Topic	Convertible roof - C flap Bowden cable replacement
Market area	Worldwide Bentley (1WBE)
Brand	Bentley
Transaction No.	2033467/1
Level	EH
Status	Approval
Release date

Technical product information

Convertible roof - C flap Bowden cable replacement

Figure 1

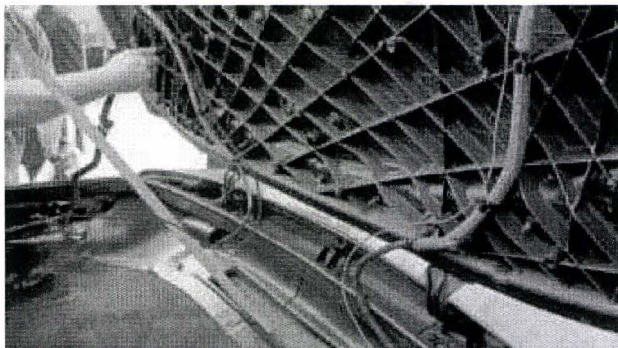
Figure 1 depicts the original routing of the Bowden cables. Note the sharp radius of the Bowden cable and the multiple clips securing the cable to the tonneau cover all these contribute to the increased friction in the system. The new arrangement removes the sharp radius and deletes all but one of the clips securing each cable to the tonneau cover

Figure 2 depicts the new longer cables following the cross over routing

Figure 3

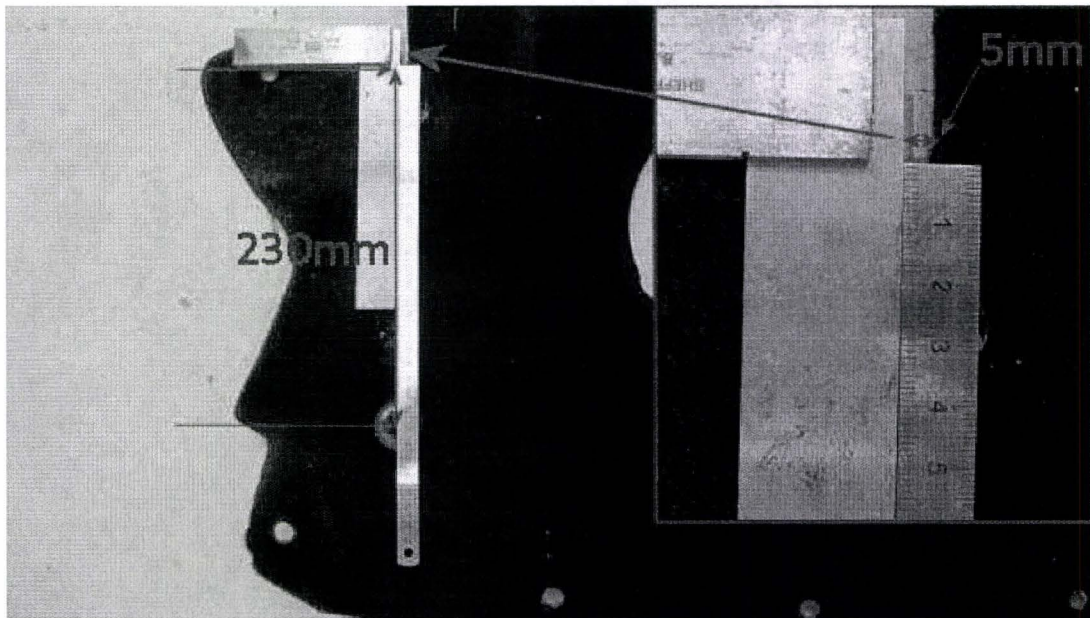
1. Produce two 30 mm holes in the tonneau carpet panel. Position each hole at 230mm along a line drawn 5mm out and at 90° to the vertical C flap cut out on the panel (see Figure 3, 4 and 5) Note in Figure 3 and 4 above the hole position has been highlighted by a white chalk circle
2. To fit the new longer re-routed cross over Bowden cable take into account the following operations in addition to the workshop manual procedure Rep. Gr 61 C flap Bowden cable – To remove and fit

Figure 5

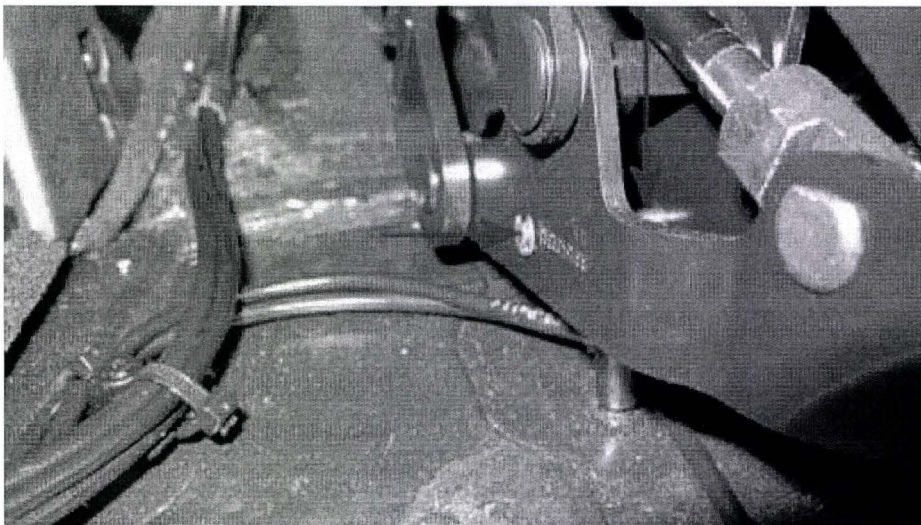
3. The pin securing the drive end of the Bowden cable can, for ease of assembly, be inserted in either direction (see Figure 5)

Figure 6

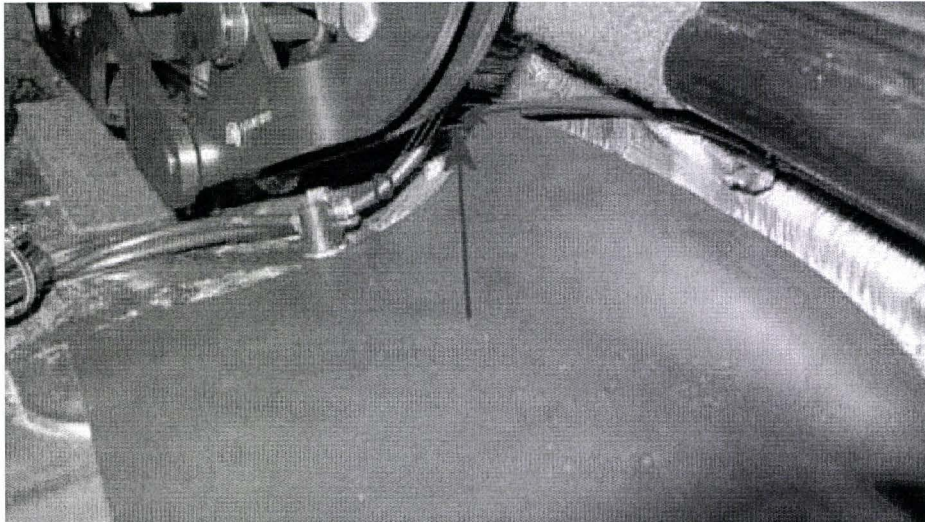
4. Ensure the new Bowden cable, arrowed, passes under cable cluster D (see Figure 6)

Figure 7

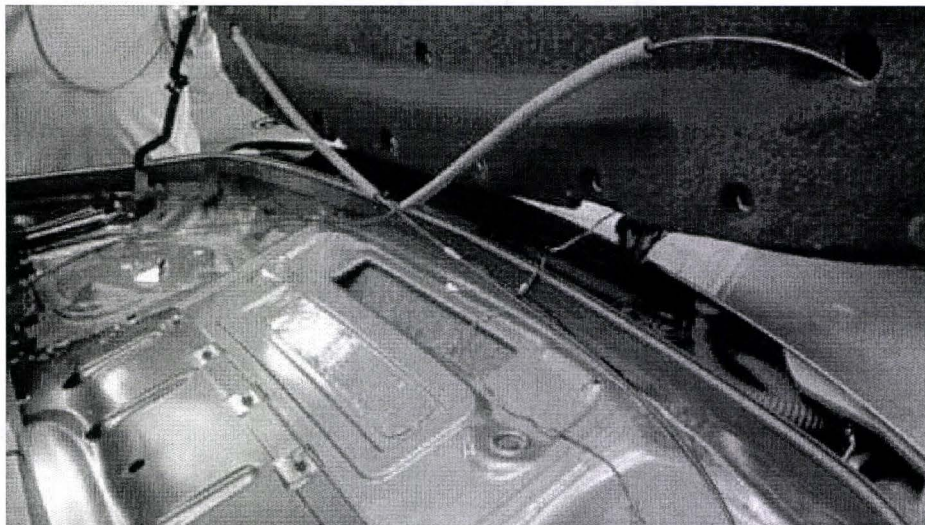
5. Loosely position the modified tonneau carpet panel feeding the right Bowden cable through the hole produced in the left hand side of the carpet and left hand Bowden cable through the right hand hole (see Figure 7)

Figure 8

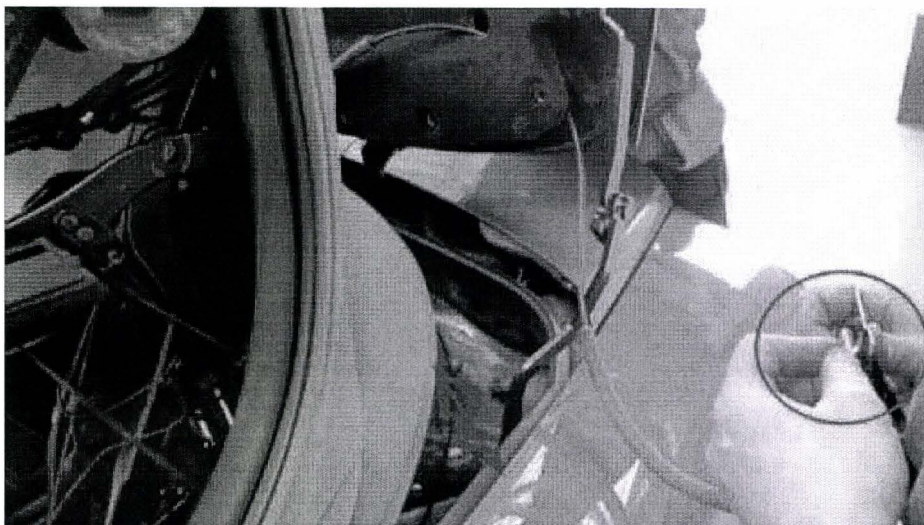
6. When connecting the new Bowden cable to the C flap the hood will need to be lowered to produce sufficient length in the Bowden cable to enable its attachment to the C flap (see Figure 8)

Figure 9

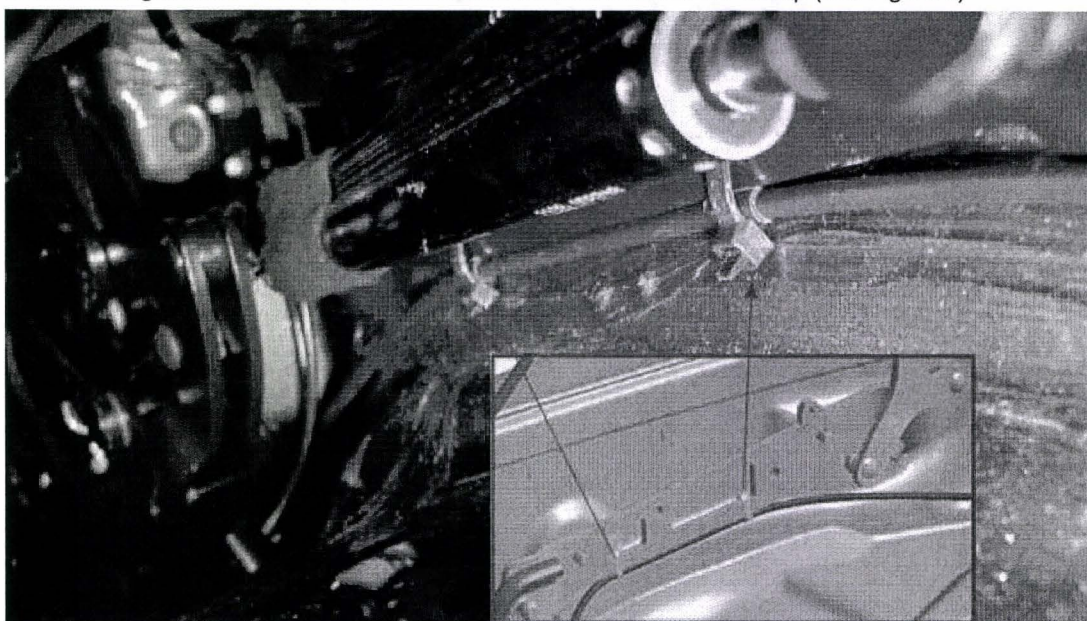
7. Start clipping the cables at the two new positions under the tonneau cover hydraulic ram as per TPI 2033508. Ensure the cable ties are placed at the points identified by the ring of black tape (see Figure 9)

Figure 10

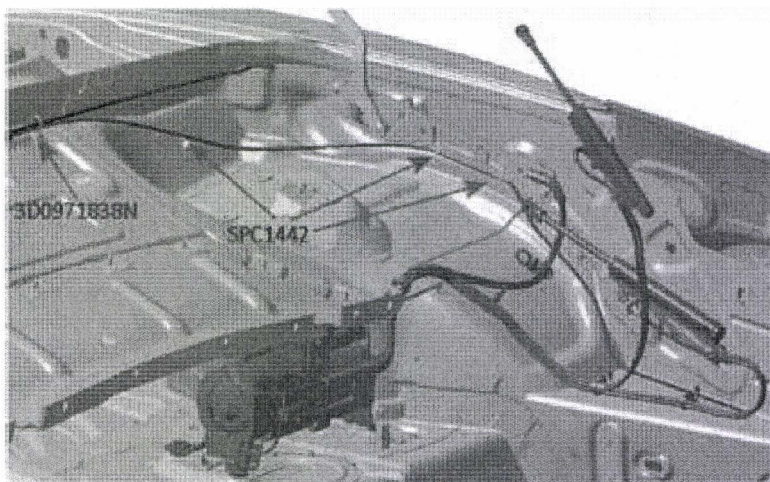
8. For each of the two new Bowden cables three SPC 1442 and one 3D0971838N cable tie are used in the locations shown in figure 10 and one original clip shown in figure 11, all other clips that were previously used to retain the Bowden cable must not be used and therefore can be removed and discarded (see Figure 9,10 and 11)

Figure 12

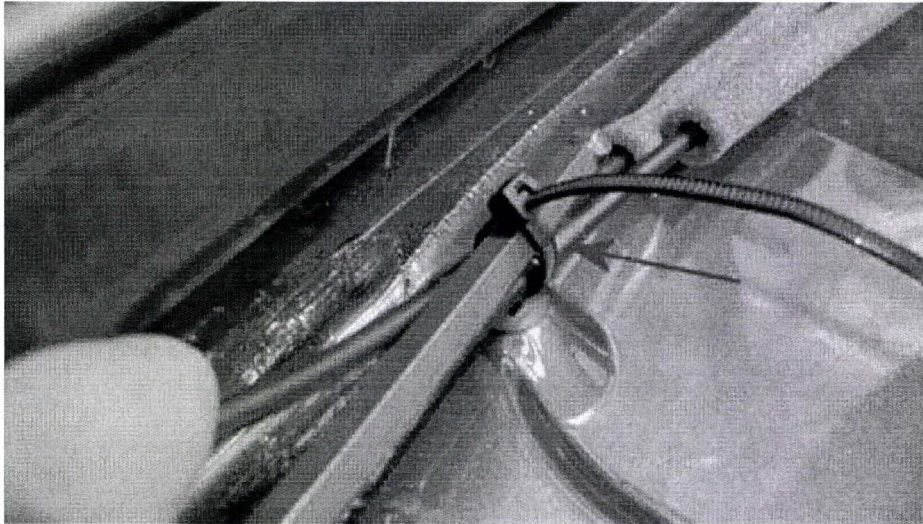
9. The new Bowden cable has the clipping points identified with a ring of black tape, ensure these markers are aligned with each clip. When clipping the Bowden cable do not over tighten the cable ties, figure 12 shows an Allen key used to gauge the cable tie pull down ensuring a running clearance is produced and over tightening does not occur

Figure 13

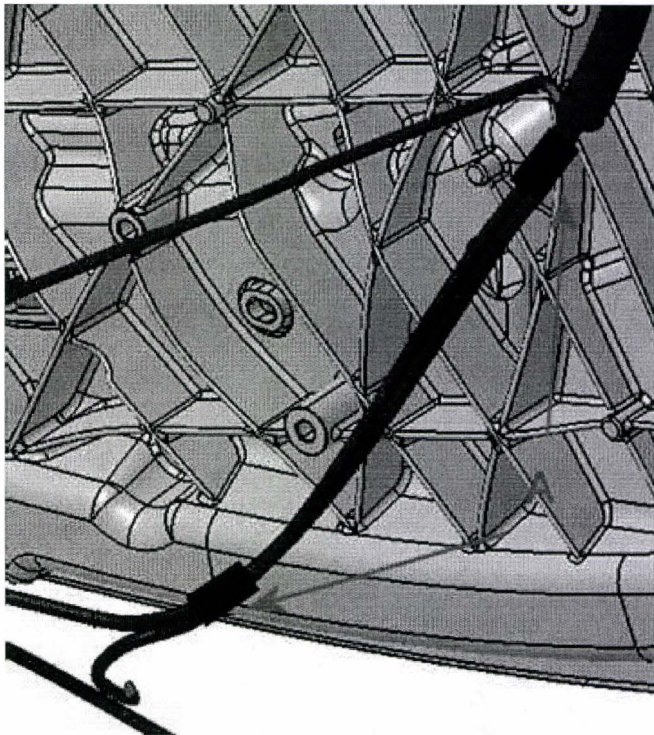
10. Disconnect the high mounted stop lamp cable at the body plug to enable it to be routed through the modified tonneau cover panel. Tape the high mounted stop lamp cable to the new Bowden cable at points (A) figure 13 then fit the longer cable obscuration sleeve (part number 3W7937115B) to the high mounted stop lamp supply cables before reconnecting the body plug (see Figure 14)
11. **Note:** If the obscuration sleeve, part number 3W7937115B is not available the original sleeve fitted to the vehicle can be used with the addition of a section of black tape

Figure 15

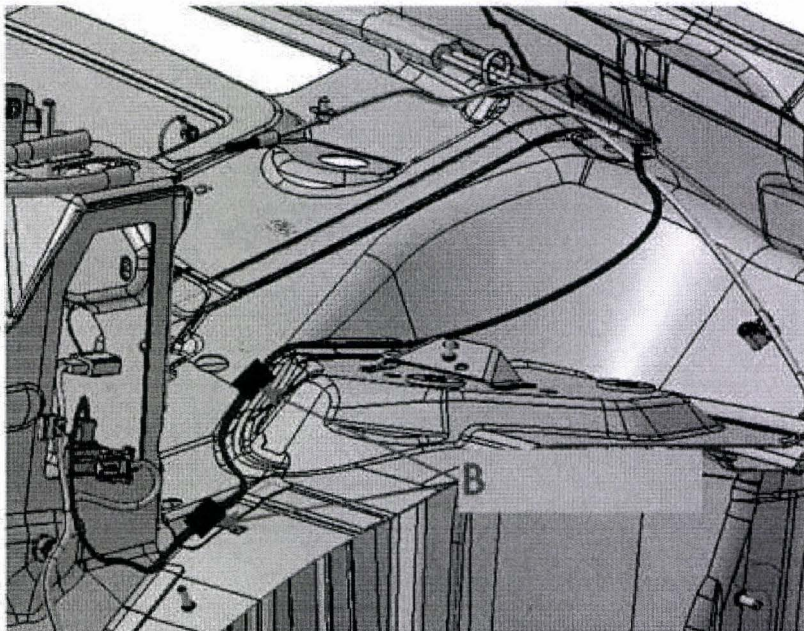
12. Follow the remaining refit procedure as contained in the workshop manual, taping down the high mounted stop lamp cable (B figure 15) to the painted body before fitting the new stowage compartment lower carpet (part number 3W7863479F) in the process (see Figure 16). Reference Rep. Gr 61 C flap Bowden cable – To remove and fit
